**City  
of  
YUBA CITY** Utilities Department

Re: *In the Matter of the Petition of the California Sportfishing Protection Alliance (City of Yuba City NPDES Permit): Comments Regarding Draft Order*  
SWRCB/OCC File No. A-1895 – November 18, 2008 Board Meeting

# City of Yuba City NPDES Permit

**Figure 1: Acute Dilution Factors for 40-Port and 25-Port Diffusers for Feather River Flowrates.**

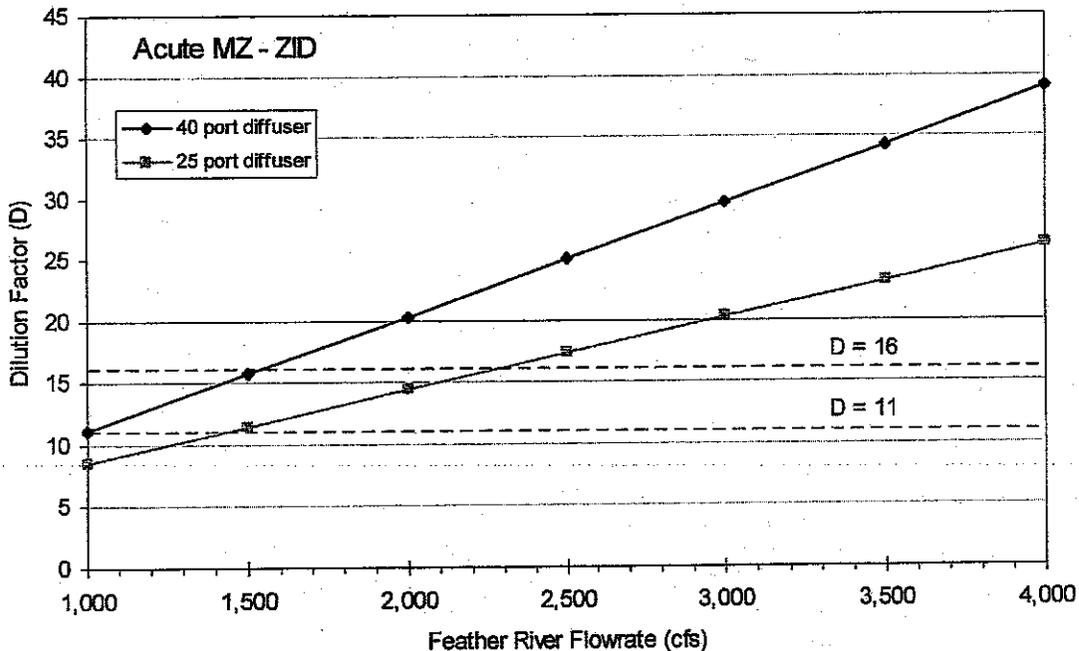
Dilution factors calculated using the CORMIX model for the discharge are plotted in Figure 1 (acute) and Figure 2 (chronic) for Feather River flowrates ranging from 1,000 to 4,000 cfs. For the historic condition of a diffuser with 25 ports open and a Feather River flowrate of 2,500 cfs, the acute dilution at complete vertical mixing is dilution factor "D"  $D=17.3$  and for the diffuser with 25 ports open and a Feather River flowrate of 3,000 cfs, the acute dilution at complete vertical mixing is  $D=20.3$ . As can be seen from Figure 1 and 2, in both cases these dilution factors are greater than the dilution provided by the diffuser with 40 ports open at 1000 cfs. In other words, the dilution provided by the diffuser with up to 15 ports covered at flows above 1500 cfs will provide equal or greater dilution than the full 40 port diffuser at the critical low river flowrates on which permit limitations are based.

## Monitoring and Maintenance of Outfall Diffusers

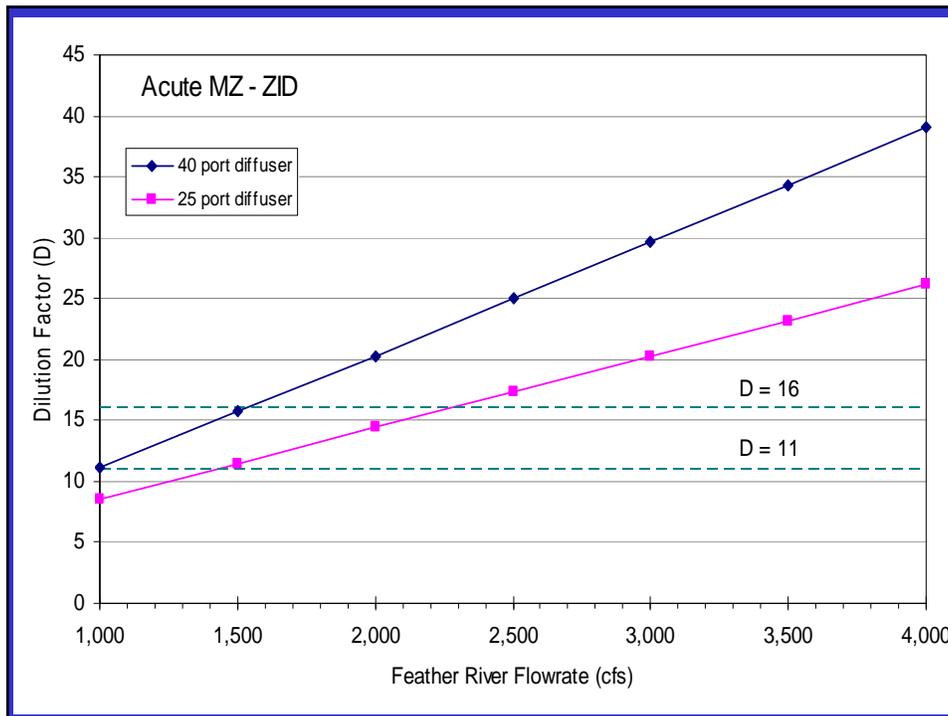
- Diffuser cleared November 2006
  - Inspections since required minimal maintenance
  - Permit requires annual inspection before low flows
- Dilution with 25 ports at 1500 cfs provides more dilution than 40 ports at 1000 cfs
